SARAJIAN & BAUM
PLLC

April 23, 2025

RE: Weinberger Subdivision Amendment

WEINBERGER SUBDIVISION
VILLAGE OF MONTEBELLO
ROCKLAND COUNTY, NEW YORK
GRADING & DRAINAGE PLAN (1 OF 4)

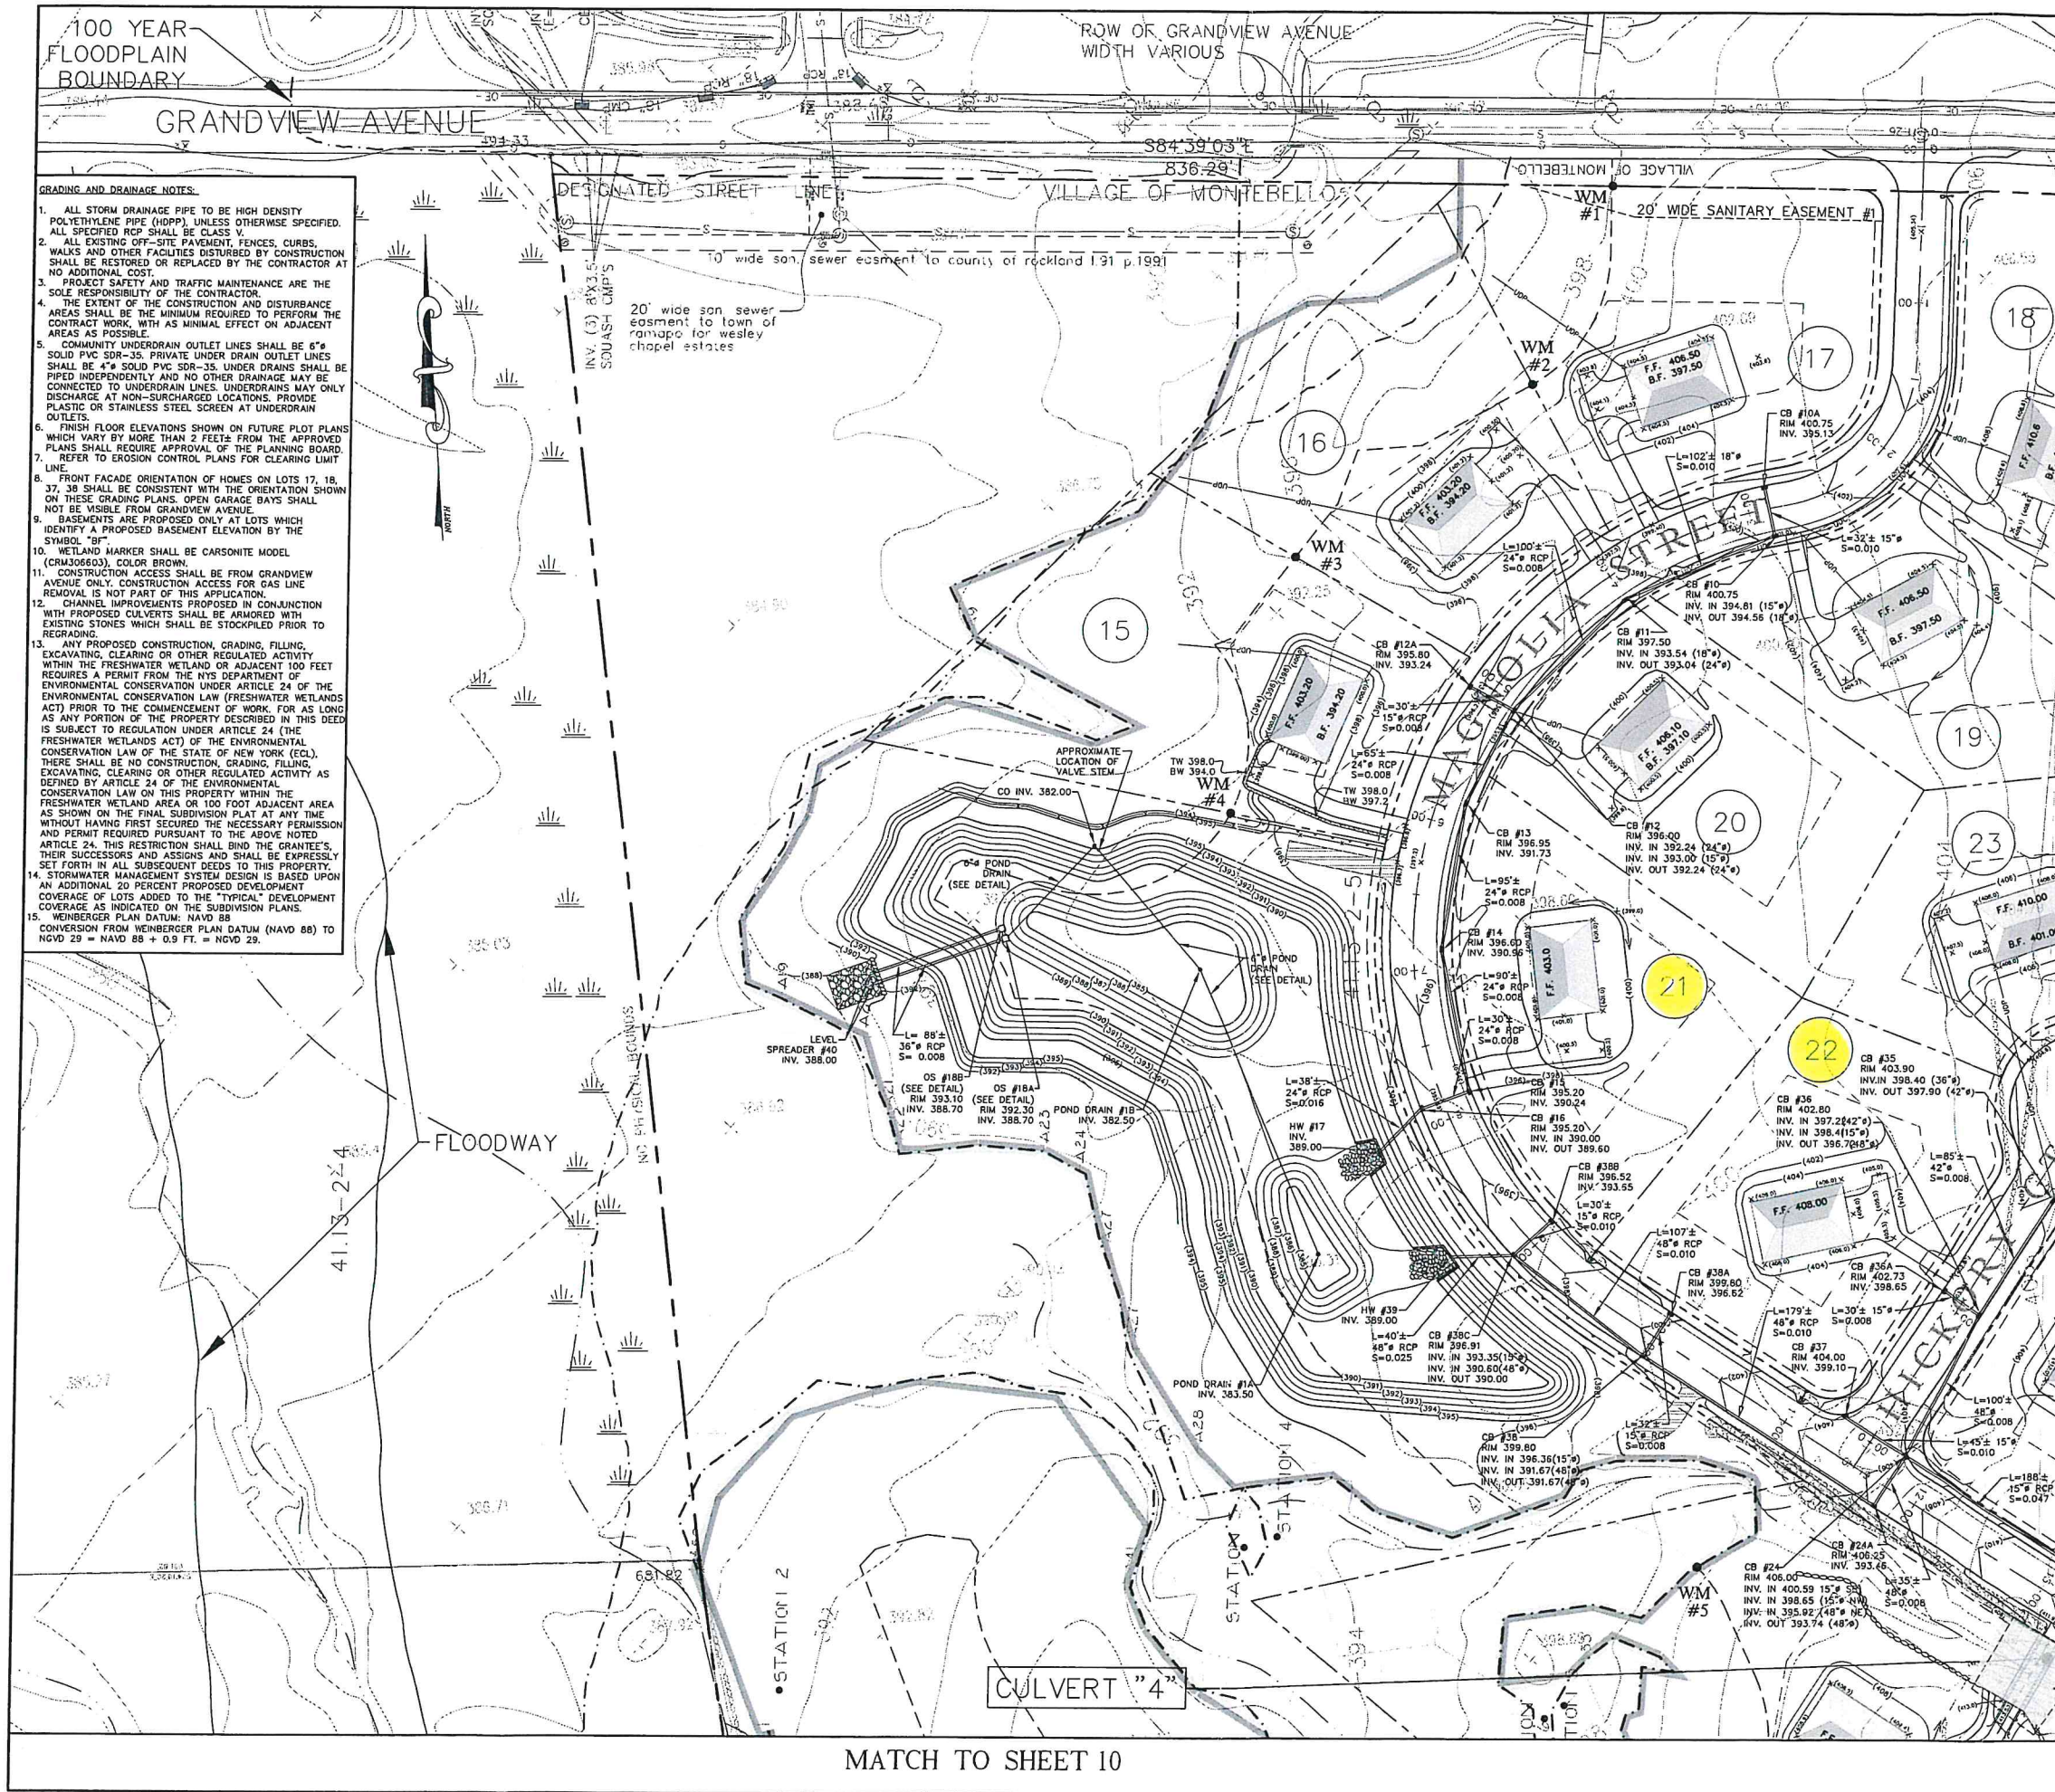
The Grading & Drainage Plan (Exhibit D) shows that Lots 21, 22 & 24 do not contain a “B.F.” denomination and thus are prohibited from having basements or below grade stories. Presumably, the reason for the prohibition was due to a high-water table and the concern that the water would seep into the basements. However, an upstream culvert that was installed to divert stormwater coming from the Village of Wesley Hills was successful in reducing the water table in the area such that there is no basis to continue the prohibition of basements on those lots. From an engineering and construction standpoint, these lots can be safely improved with basements and appropriate water control methods so that the basements will be dry and there will be no hazard to public health, safety and welfare.

Potential purchasers of these lots expressed the desire to have basements in the homes to be constructed. Therefore, we submit that the restriction of basements on these three lots should not required and we seek amended subdivision approval to remove Condition No. 11 from the approval resolution.

WEINBERGER SUBDIVISION
VILLAGE OF MONTEBELLO
ROCKLAND COUNTY, NEW YORK
GRADING, DRAINAGE & UTILITY PLAN (SECTION A)

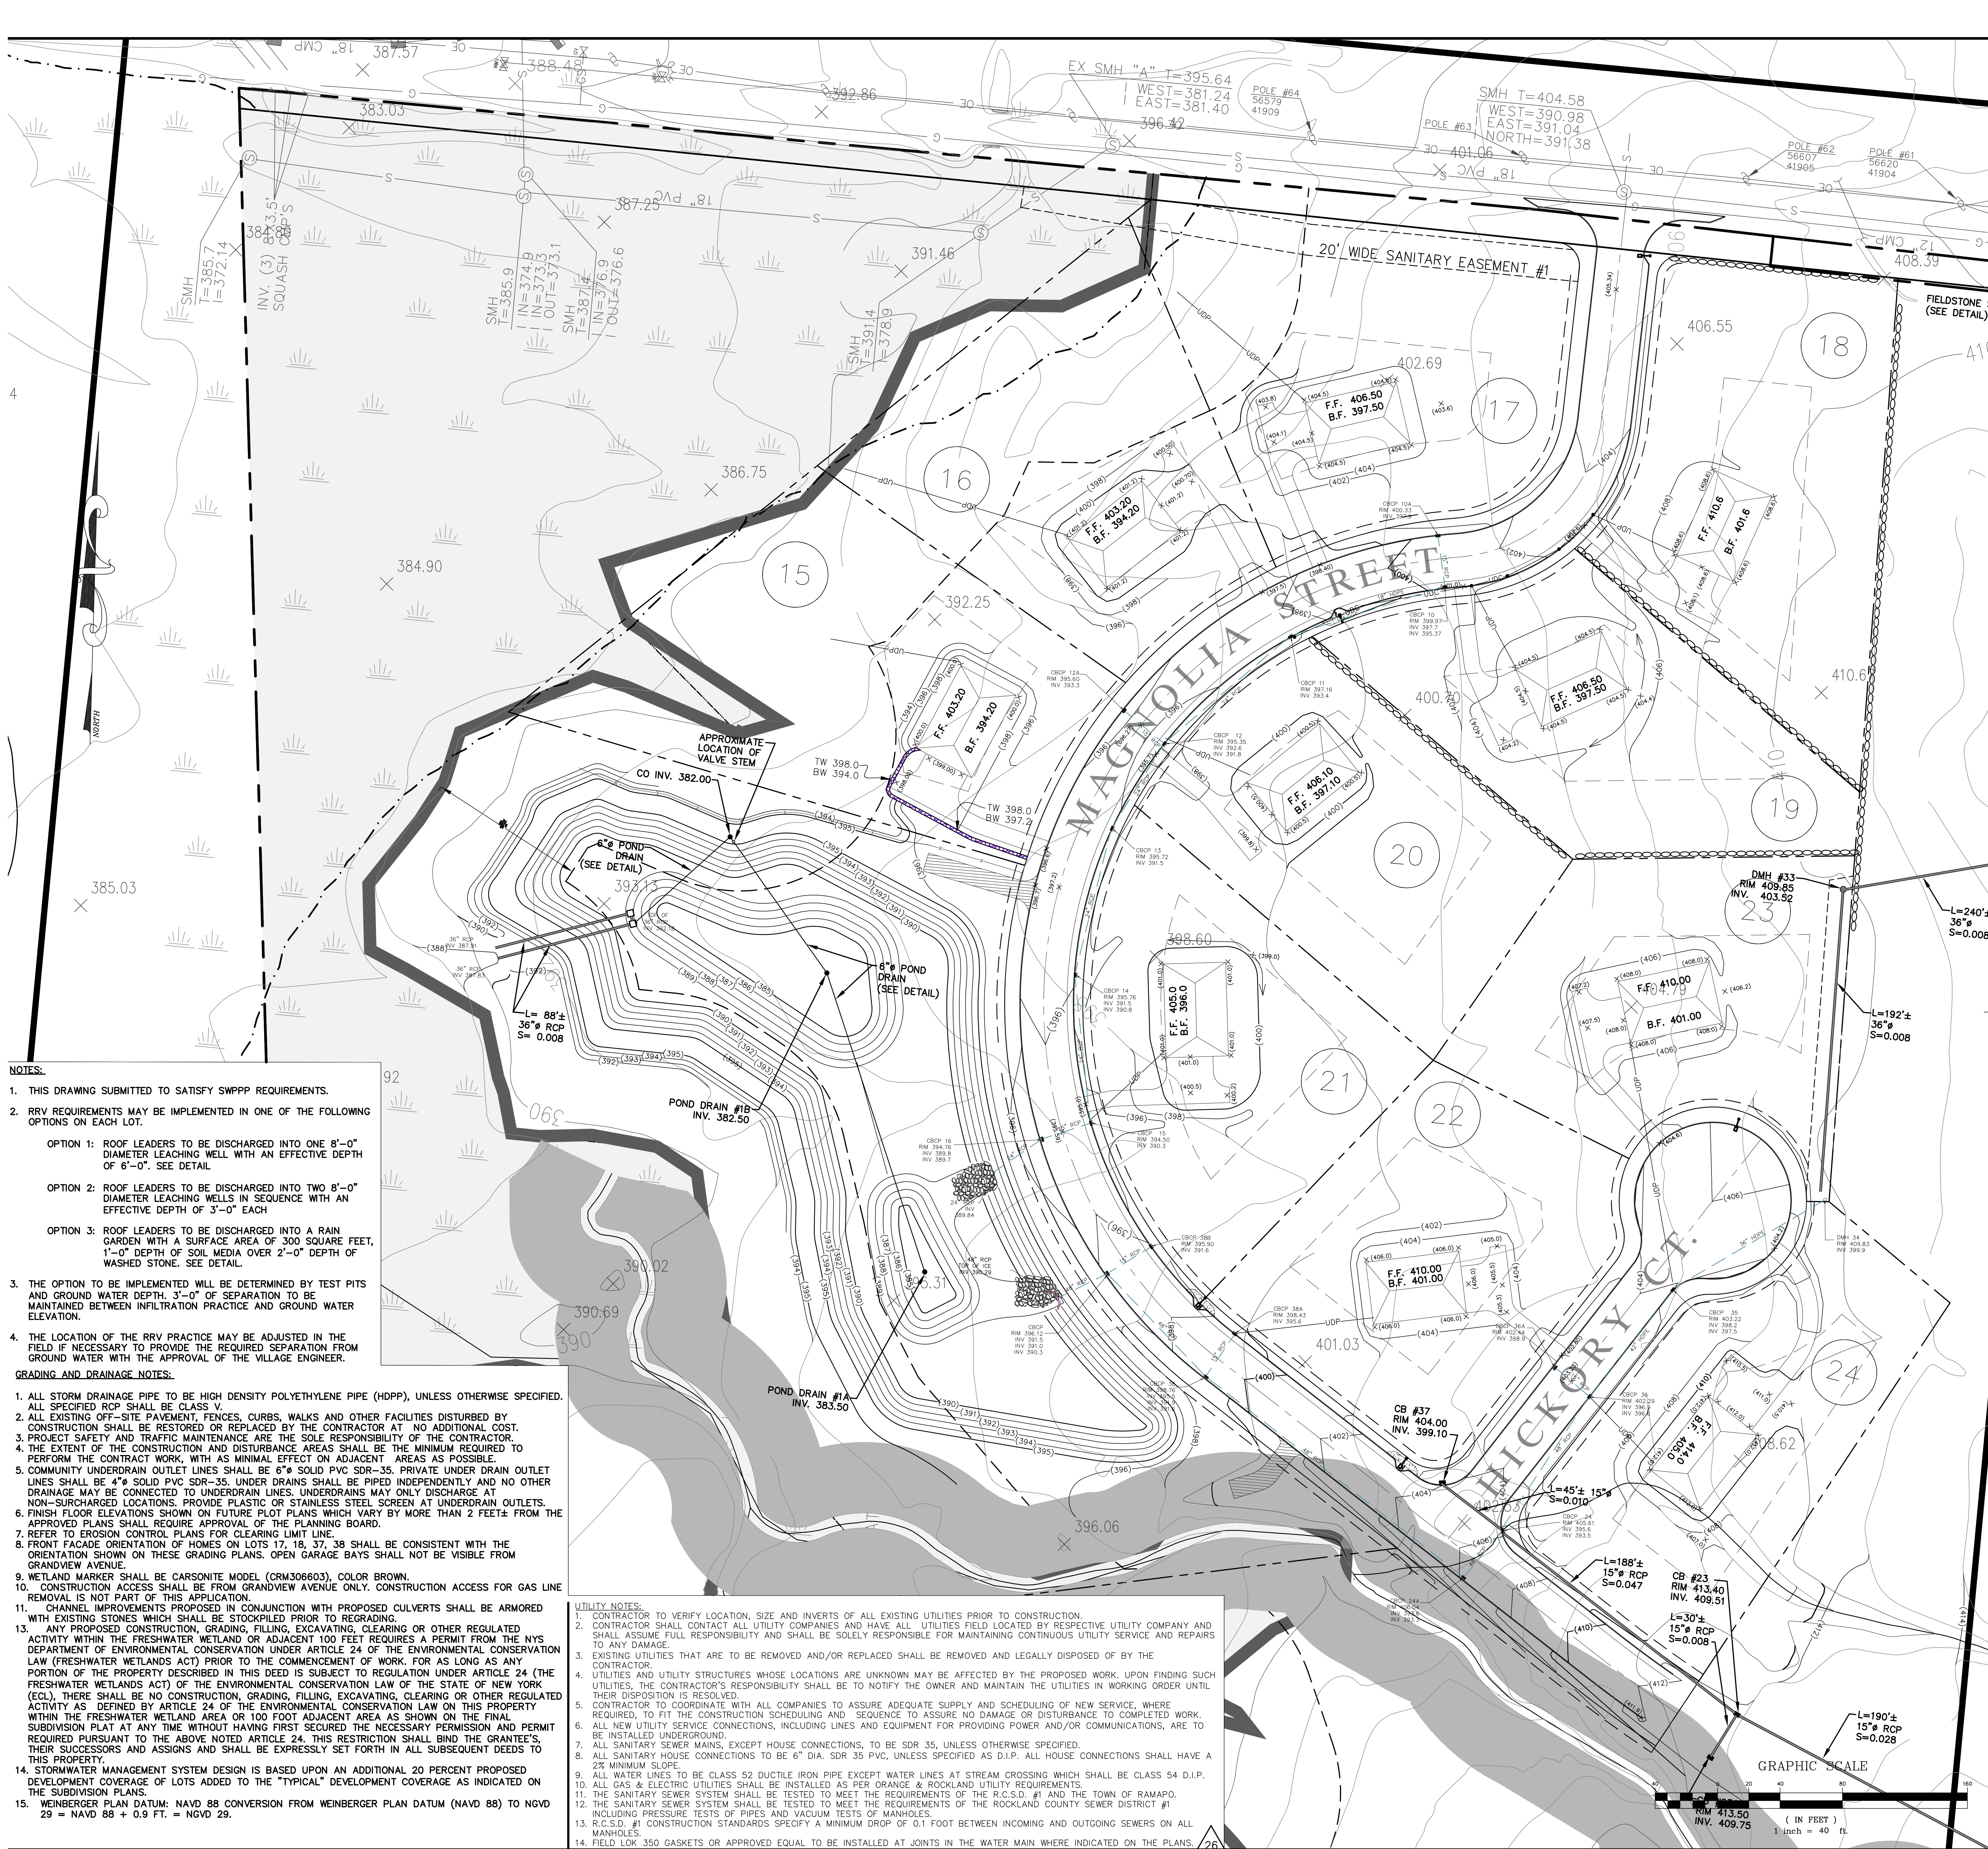
Verify proposed rim of CB38A, our design documents show 398.60, where your report references a design elevation of 399.80

Verify proposed rim of CB15, our design documents show 394.96, where your report references a design elevation of 395.20.

This Underdrain Report was revised in response to comments provided by Spence Engineering dated March 23, 2025. The as-built inverts and the design rim elevation and the as-built rim elevations for CB 38A and CB 15 have been provided.

We propose to provide an underdrain (See the foundation underdrain detail Dwg. # 33) connection to proposed CB # 36 (design rim elevation 402.78) in Hickory Court. The as-built survey determined the existing rim of this catch basin is 402.29 with an invert of 396.6. The 4"Ø underdrain to be constructed with an invert of 400.75 into the catch basin.

We propose to provide an underdrain (See the foundation underdrain detail Dwg. # 33) connection to proposed CB # 38A (design rim elevation 398.6) in Magnolia Street. The as-built survey determined the existing rim of this catch basin is 398.43 and the invert is 395.6. The 4"Ø underdrain to be constructed with an invert of 396.1. into the catch basin.

We propose to provide an underdrain (See the foundation underdrain detail, Dwg. # 33) connection to proposed CB # 15 (design rim elevation 394.96) in Magnolia Street. The as-built survey determined the existing rim of this catch basin is 394.5 and the invert is 390.3. The 4"Ø to be constructed with an invert of 392.2 into the catch basin.
